## **ULAN COAL MODIFICATION 6 AMENDMENT – UNDERGROUND MINING EXTENSION**

Response to Independent Expert Scientific Committee on Coal  
Seam Gas and Large Coal Mining Development Advice

Project Director: Kirsty Davies  
Project Manager: Matthew Copeland  
Report No. 20020/R12  
Date: August 2024

**Figure 3.1 Predicted depth to water table for key mining stages of the Amended mine plan**

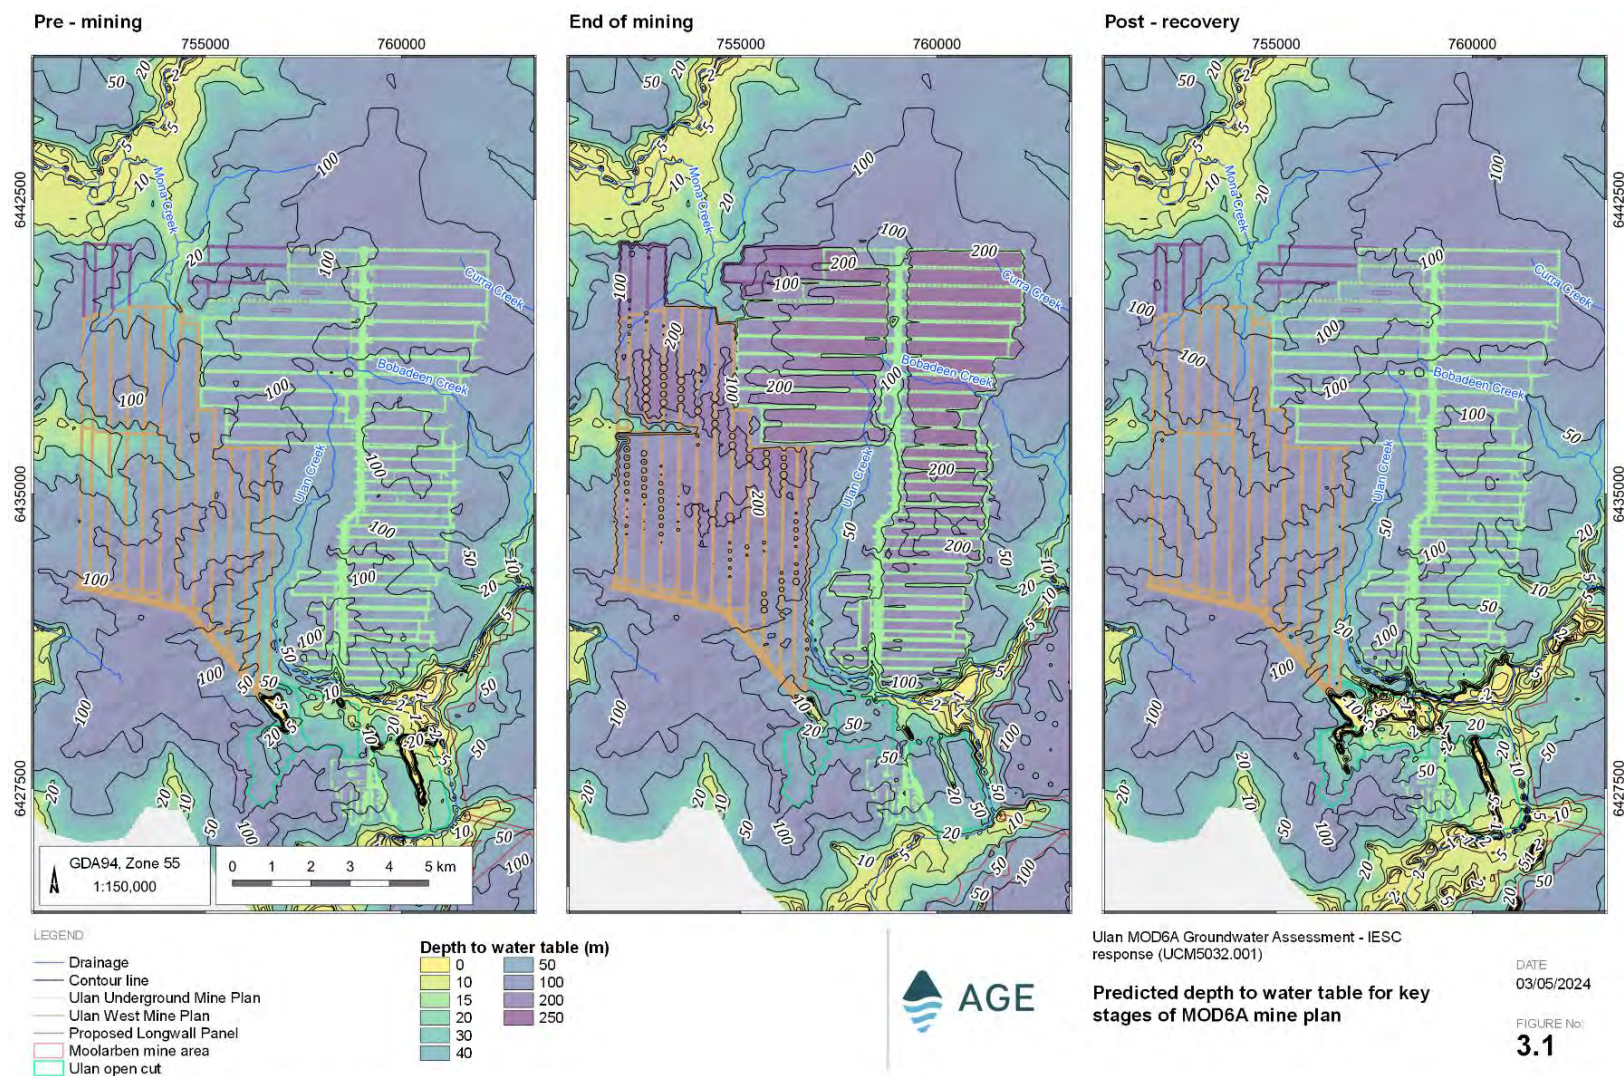
d. Mapping of the current depth to the water table, overlain with persistent pools and any potential groundwater-dependent vegetation to help understand the likely groundwater dependence as recommended by the peer review of the groundwater model (AGE 2022, App. C1, p. 2).

The existing depth to water table (refer to **Figure 3.1**) in the area where woodland is mapped indicates the regional water table is greater than 10 m below ground level (mbgl) and is likely below the rooting depth of these riparian trees. Monitoring from the MCMB01 nested bores suggests the vegetation in the upper catchment of Mona Creek may utilise shallow groundwater in the unconsolidated sediments but also indicates this shallow groundwater is disconnected from the regional groundwater regime. As a result, aquatic and hyporheic ecosystems within the Mona Creek environment (including those related to base flow and refugial pools) will be unaffected by the changes in regional water table associated with mining in this area.

**Figure 3.3** Groundwater level and phreatic surface for MCMB and VWP site DDH598

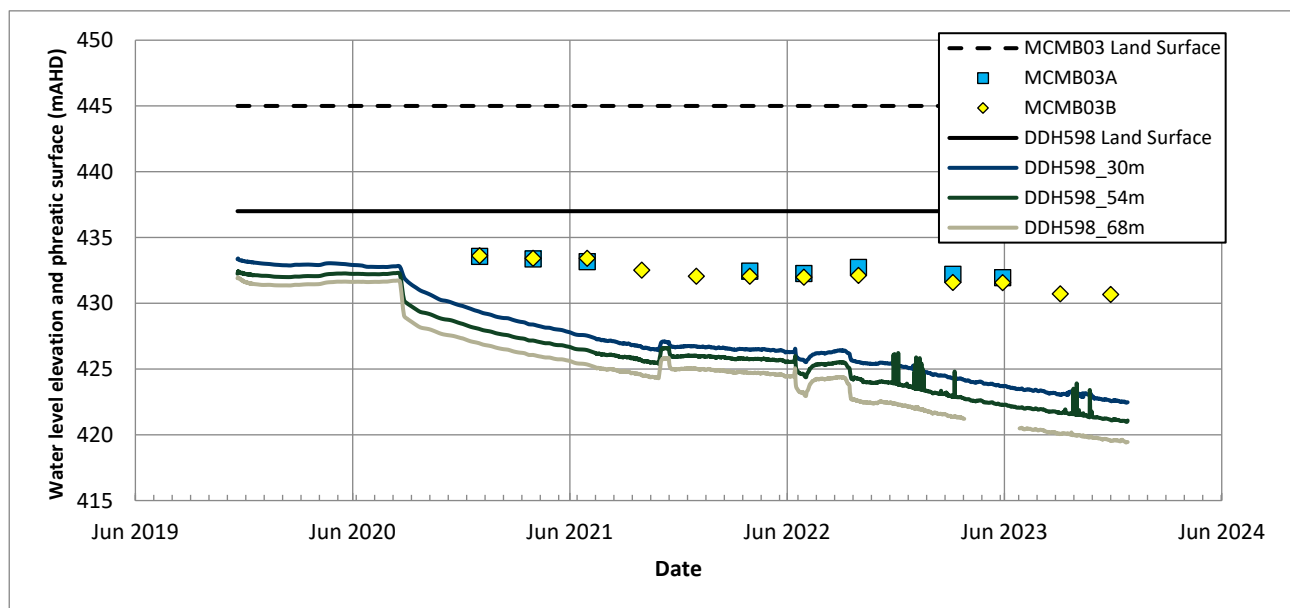
b. Clear presentation of data collected from the Mona Creek bores is required to establish the baseline groundwater conditions, particularly the depth to groundwater, the extent of the aquifer and groundwater quality.

**Figure 3.3** below also shows the potentiometric surface of the Vibrating Wireline Piezometer (VWP) array for DDH598 along with the water levels in MCMB03A and B. VWP array DDH598 is located approximately 600 m away from the MCMB03 bore location and upstream with respect to Mona Creek. The surface elevations of MCMB03 and DDH598 are 445 m and 437 m, respectively. Despite being located downstream, MCMB03 bores are located on an elevated hillock adjacent to Mona Creek and, therefore, the elevations of the base of MCMB03B and the DDH598\_30m sensor in DDH598 are considerably different: 415 mAHD for MCMB03B and 407 mAHD for DDH598\_30m. Comparison of groundwater level elevations between the bores and the VWPs indicates a significant separation between the monitoring bores and the shallow VWPs. The three shallowest VWPs all show similar phreatic surface elevations (within 2 m) and very similar trends of gently declining porewater pressure. The MCMB03 bore show a considerably different trend with only a slight decline between 2021 and 2023, and water levels approximately 6 m higher than the VWPs. This suggests that the MCMB03 bores are recording water levels in a shallow, perched, aquifer that is separated from the regional groundwater flow regime measured by the VWPs, which is also supported by the dry deeper bore at MCMB01.

Remnant Ponding  
and CEEC within  
Mona Creek Catchment

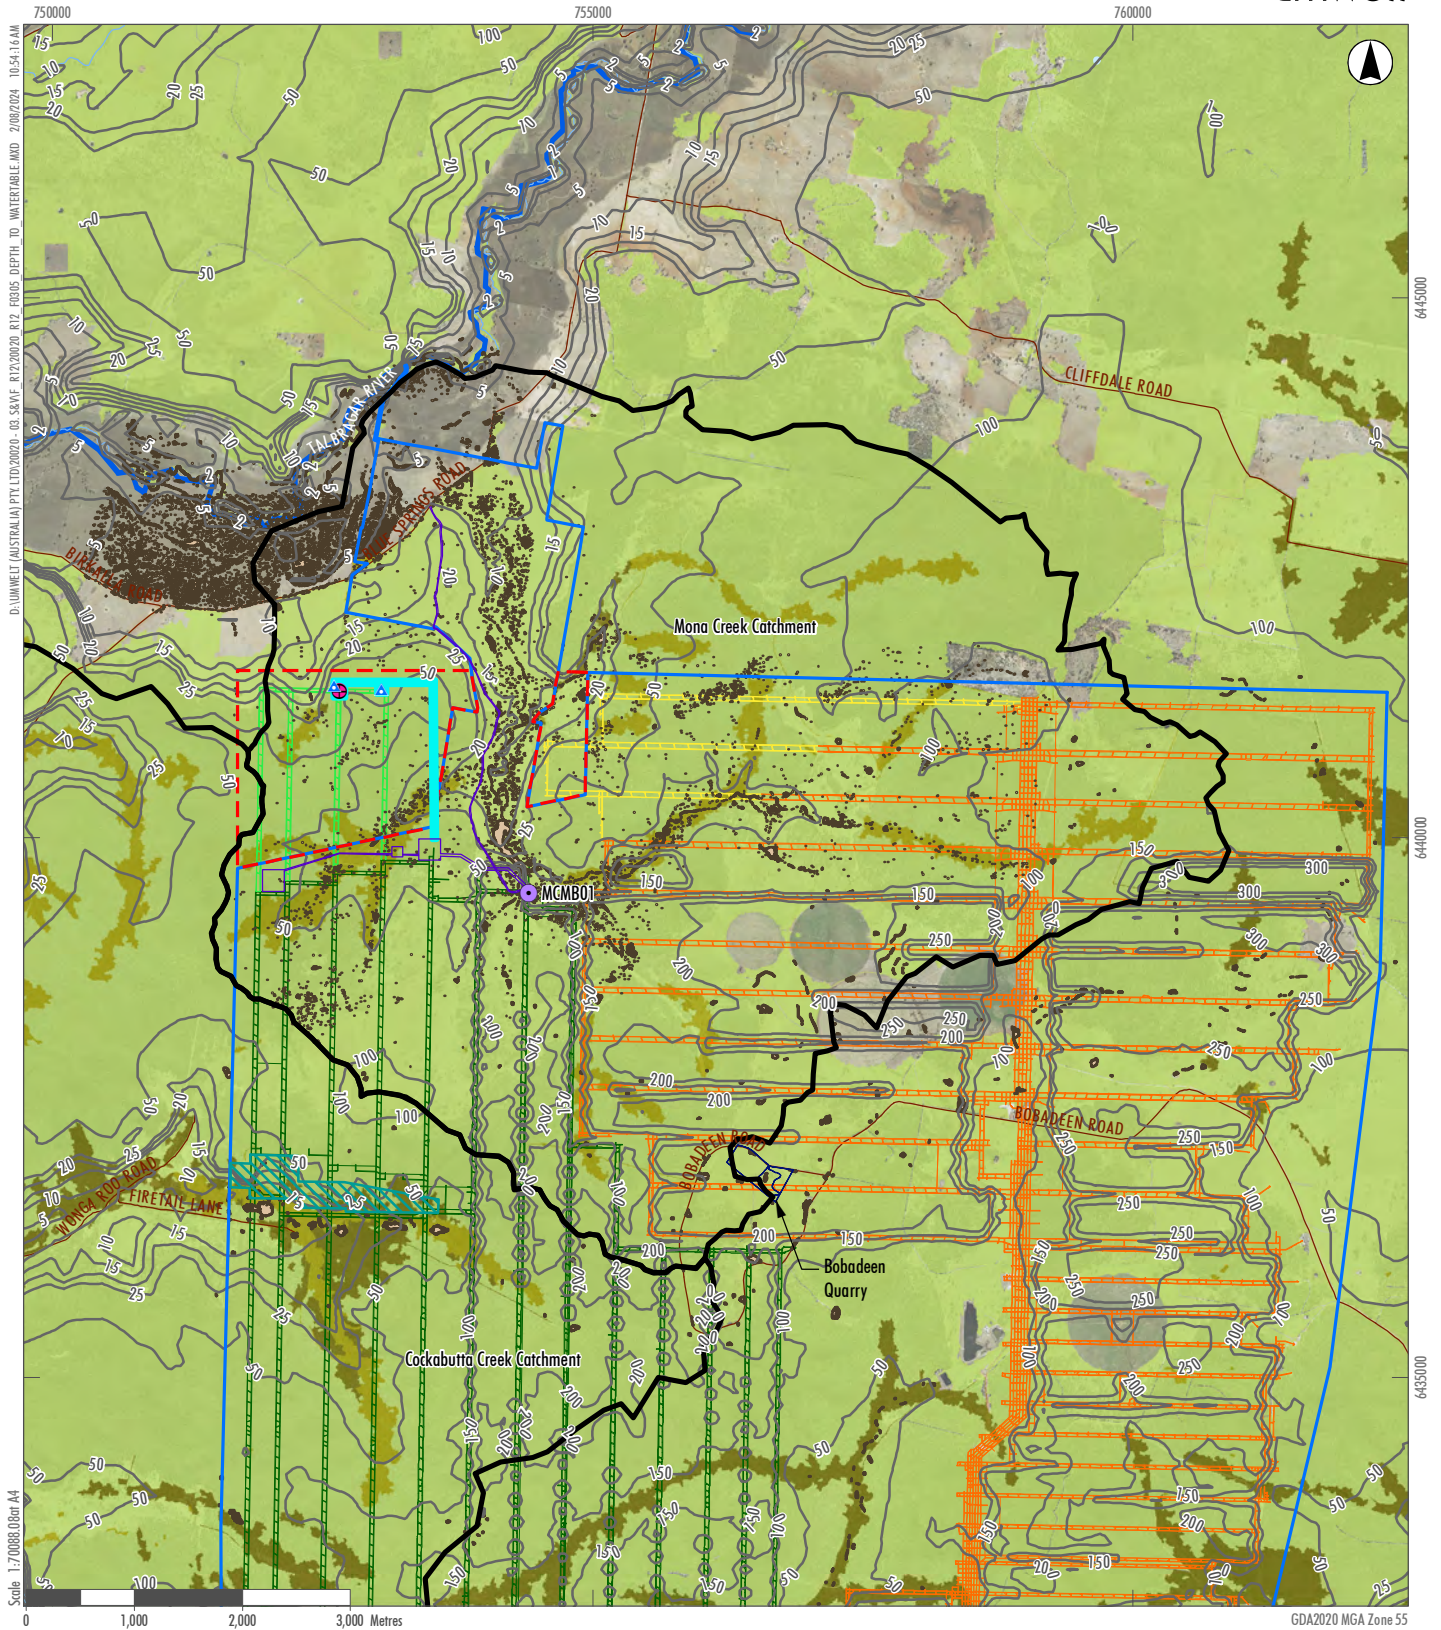
c. Identification and mapping of persistent pools (AGE 2022, p. 29) and the CEEC (Umwelt 2022a, p. 114) that occur within the Mona Creek area.

The extent of White Box – Yellow Box – Blakely’s Red Gum Critically Endangered Ecological Community (Box Gum Woodland CEEC) was mapped in the Amended BDAR for the Amended Modification (Appendix 8 of the Amendment Report). This mapping has been overlain on the Mona Creek catchment area with current areas of remnant ponding in **Figure 3.4** below. It is noted that most of the Mapped CEEC within the Mona Creek Catchment is derived grassland and not woodland vegetation.

FIGURE No:  
**3.21**

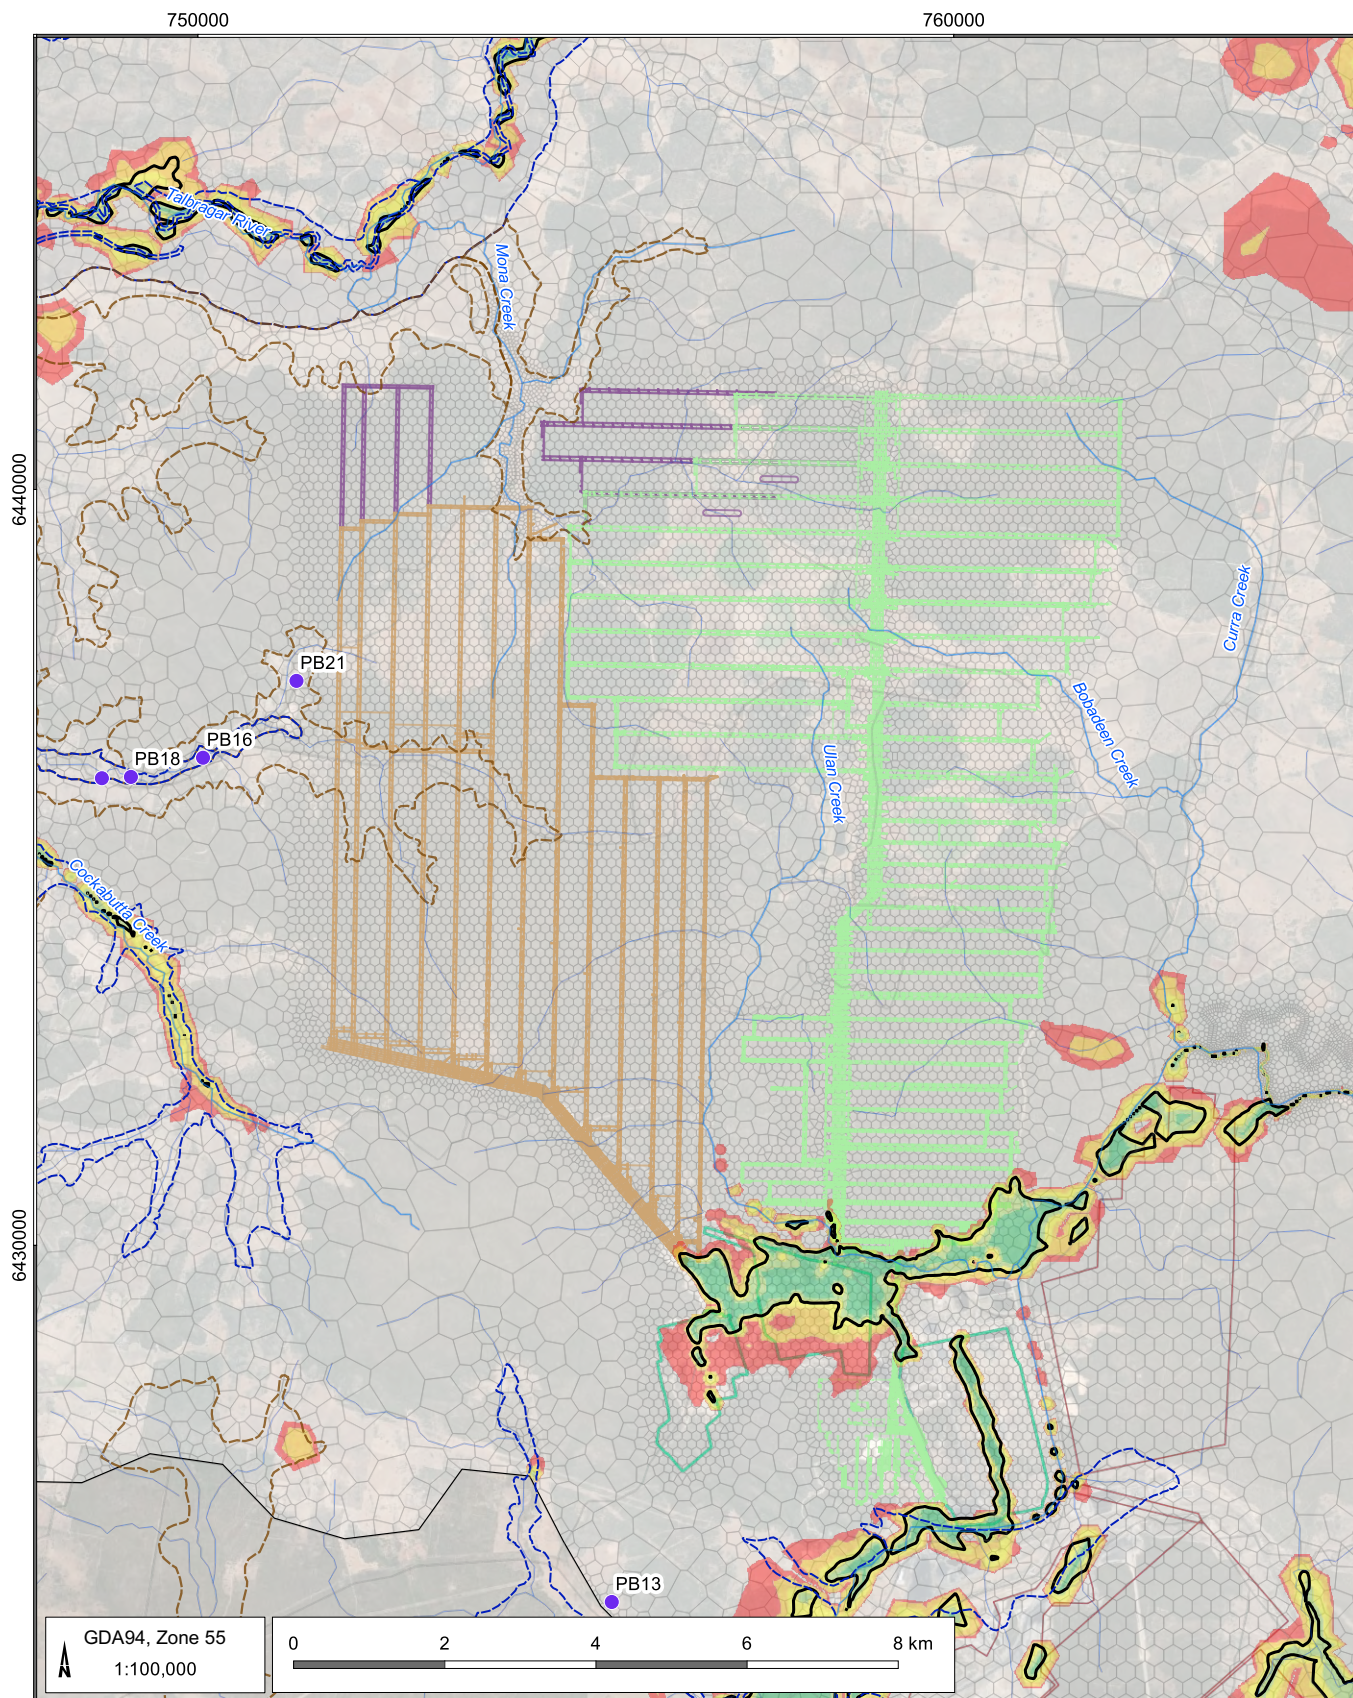
c. The cumulative drawdown predictions for the Ulan Seam extend beyond the boundaries of the groundwater model (AGE 2022, Figure 7.9, p. 86), which reduces confidence in these predictions as they are likely to be influenced by the boundary conditions.

Figure 3.21 shows that the drawdown in the Ulan Seam is likely to intercept the model boundary. These boundaries are simulated as no flow, which have an amplifying influence on the predicted depressurisation in the Ulan Seam because drawdown cannot propagate further outward past the boundaries and instead propagates vertically, thus overpredicting depressurisation in the layers above and below the seam and making these predictions cautious over-estimates of impacts.

### 3.13 Location of the Ulan Seam sub-cropping under the alluvium (11b)

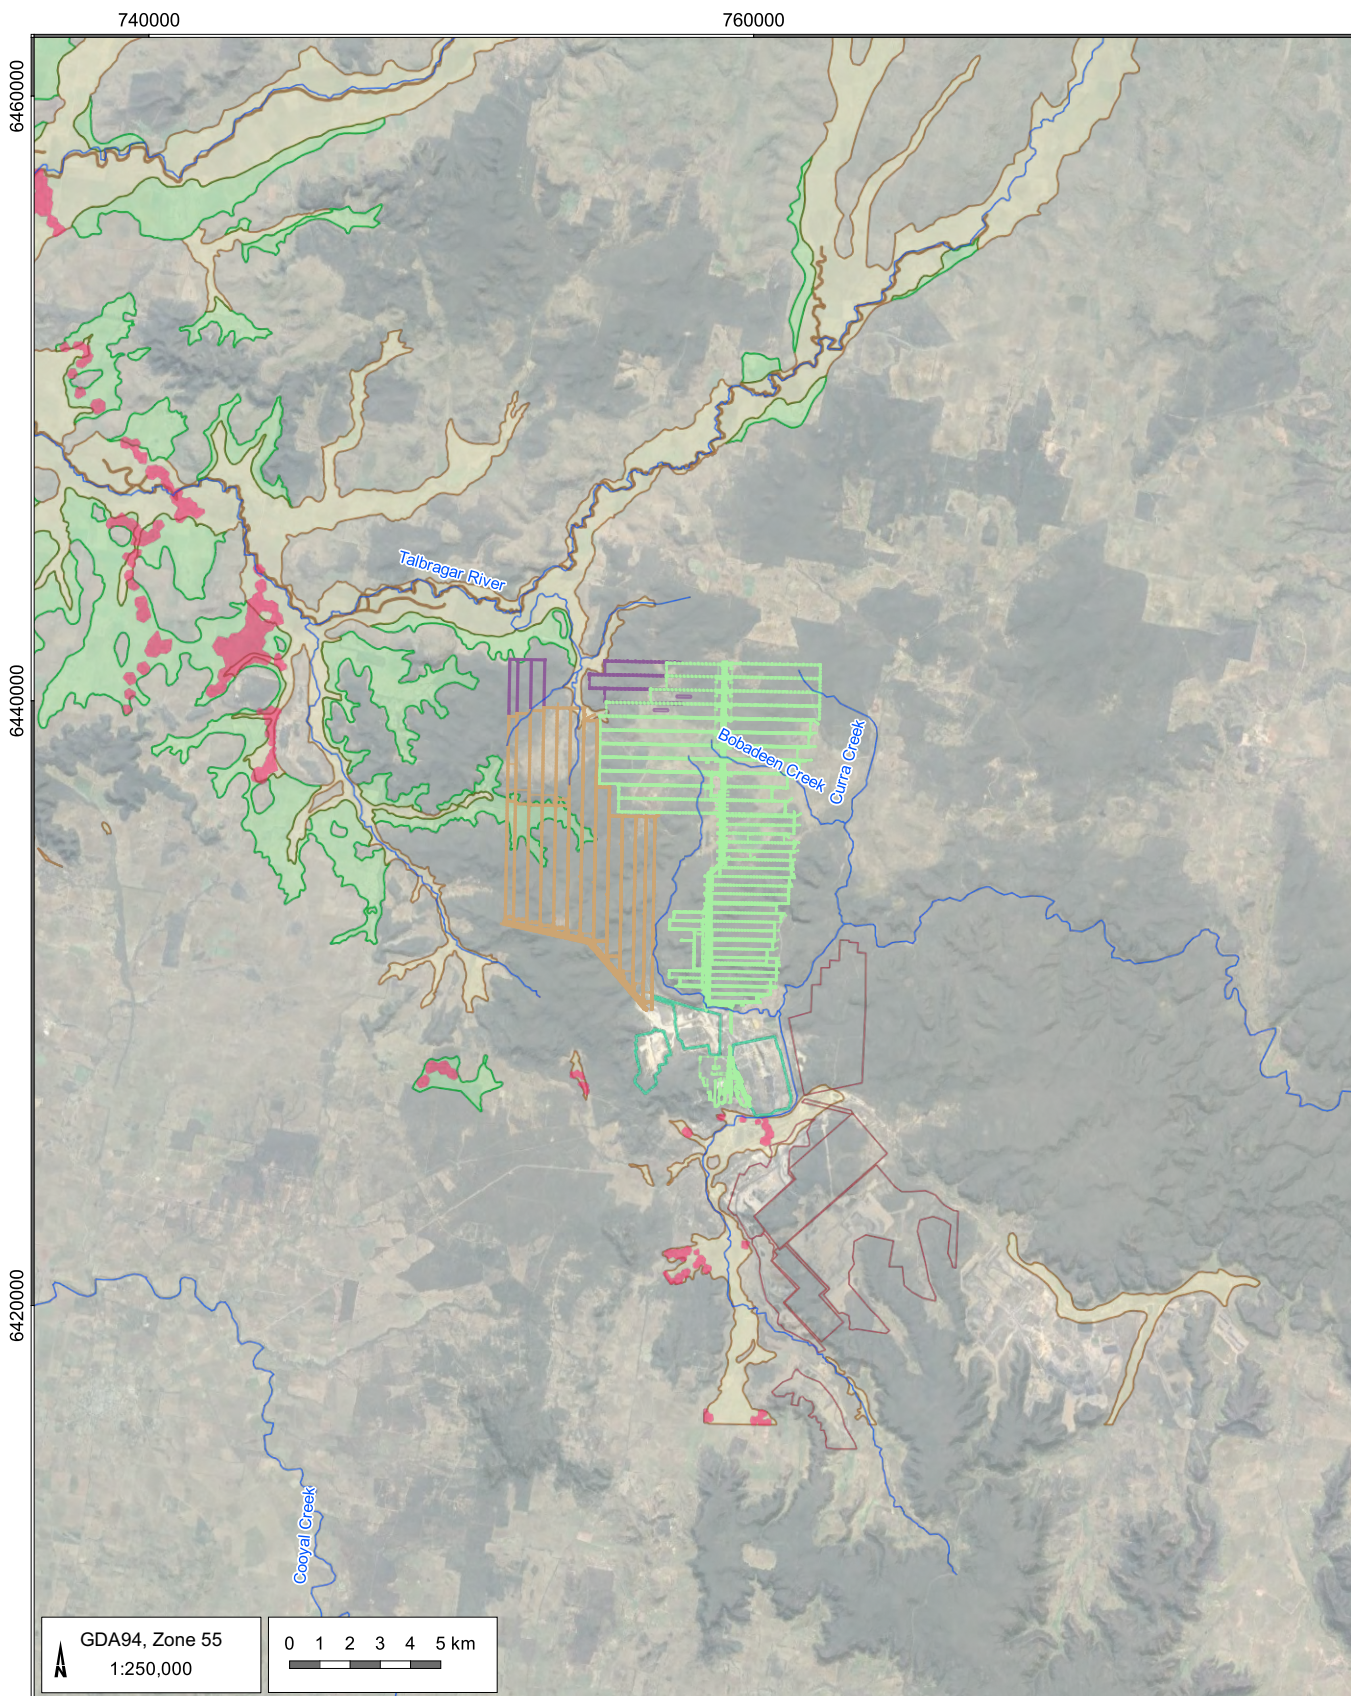
b. There are areas where the Ulan Seam sub-crops to the Talbragar River Alluvium (AGE 2022, p. 73). These areas should be identified, mapped and potential impacts discussed further given that it is predicted that drawdown in the Ulan Seam will extend under large areas of the Talbragar Alluvium (see AGE 2022, Figure 7.5, p. 81).

As requested, Figure 3.38 shows the location of the model cells where the Ulan Seam sub-crops directly under the alluvium and colluvium areas. In the model this is where layer 16 is directly below layer 1 with no intervening model layers.
